## APPROVED MINUTES OF THE MEETING

**June 4, 2009**

**Project: Yesler Terrace Redevelopment**

**June 4, 2009**                      **Project:**                      **Madison Valley Storm Water Improvements – Phase II**

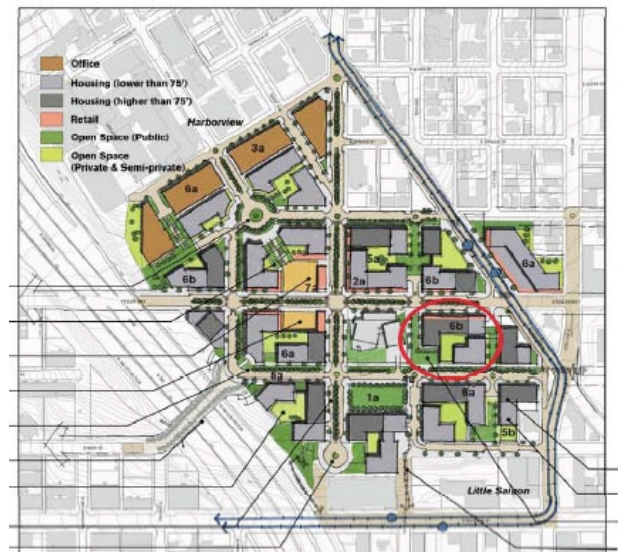
*The open spaces in all three concepts seem like they could benefit from a larger open space. The concepts seem to focus on smaller open spaces at the expense of a larger open space.*

*Concept A – the strong grid pattern, I like that aspect. I like the relationship between Harborview and the high rise office spaces. What I don't like: it doesn't take the opportunity to change the grade to benefit the development and adjacent connections.*

*Concept B addresses the history of Yesler Terrace and the unique character of the existing site and solar access.*

*The curvilinear street on Concept B seems like a "rural lane" and out of character.*

*I like Concept B where there are two hearts and the recognition the transit hub over on Boren and Yesler. On B we're grading up and creating a wall with the International District. With the proposal to build a lid over I-5 there may be some grading issues.*

*Concept B seems to require a major intervention all at once to make it work.*

One of the things we're working on is going to establish a more specific open space plan. One of our concerns is overly emphasizing a large open space and it might reduce overall use versus a more decentralized concept.

*It's designed to take advantage of the views and could be reconfigured.*

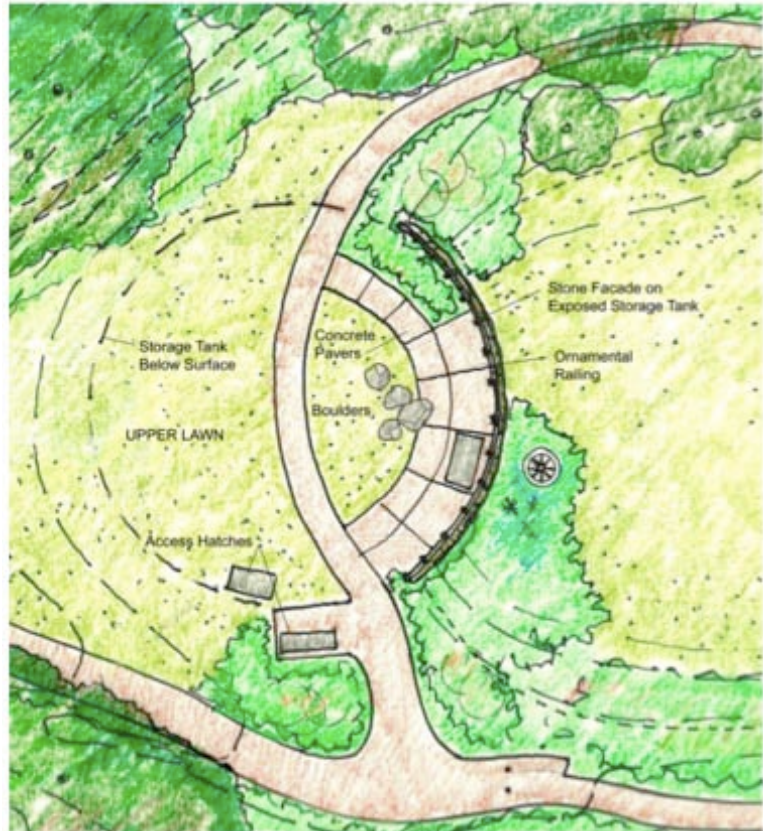
*One way that you could get in the idea of the power of water and the retention of it is to take the path around the outside of the tank to create a more powerful image of the size and scope of the tank.*

*The service road and the parking spaces need to be integrated better, particularly between the two materials for the pathways.*

*In terms of plantings, I'm excited about the types of planting you are proposing, but when I look at the site plan and the dark green and light green I'm wondering the logic of where you are locating your plantings. I'm feeling that the path orientation and the open spaces you are creating could be more intentional and graceful.*

*It seems the primary element, the tank, is fighting between being expressed and being hidden. The theme of the tank could be utilized in the pathway design as well by creating circular nodes at various points.*
